Access Compliance Report Public Rights-of-Way (Curb Ramps)

Intersection ID: 13627 Main Street: COMMONWEALTH_AV Cross Street: WESTOVER_ST Location: E

ADA ID: CE53557493E2 Ramp Type: Perp Initial Pass/Fail: Fail Overall Compliance: No Severity Score: 12.5

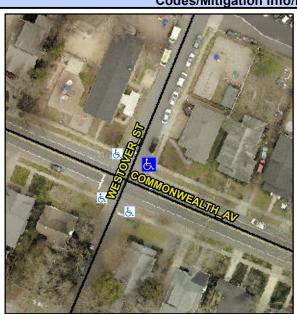
Not Found, R304.2.2

Field Measurements/Component Compliance					
Compliance Description		Data	Comp	liance Description	Data
N/A	Ramp Length (in)	80.5	No	Ramp Slope (%)	8.6
Yes	Ramp Width (in)	48.0	Yes	Ramp XSlope (%)	1.3
N/A	Flare Type LT	N/A	N/A	Flare Type RT	N/A
N/A	Flare Slope LT (%)	N/A	N/A	Flare Slope RT (%)	N/A
N/A	Flare Traversable LT?	N/A	N/A	Flare Traversable RT?	N/A
N/A	Landing Length (in)	N/A	N/A	DWS Provided?	N/A
N/A	Landing Width (in)	N/A	N/A	DWS Contrast?	N/A
N/A	Landing Slope (%)	N/A	N/A	DWS Length (in)	N/A
N/A	Landing X Slope (%)	N/A	N/A	DWS Full Width?	N/A
N/A	Landing Curb? (Y/N)	N/A	N/A	DWS Offset (in)	N/A
N/A	Shared Landing?	N/A			
N/A	Gutter Ponding?	N/A	N/A	Gutter Slope (%)	N/A
N/A	Gutter Lip Ht (in)	N/A	N/A	Gutter X Slope (%)	N/A
N/A	Painted X Walk1?	No	N/A	Painted X Walk2?	N/A
	X Walk 1 Direction	To NW		X Walk 2 Direction	N/A
N/A	X Walk 1 Width (in)	N/A	N/A	X Walk 2 Width (in)	N/A
	X Walk 1 Slope (%)	2.2		X Walk 2 Slope (%)	N/A

Remove & Replace Entire Ramp.
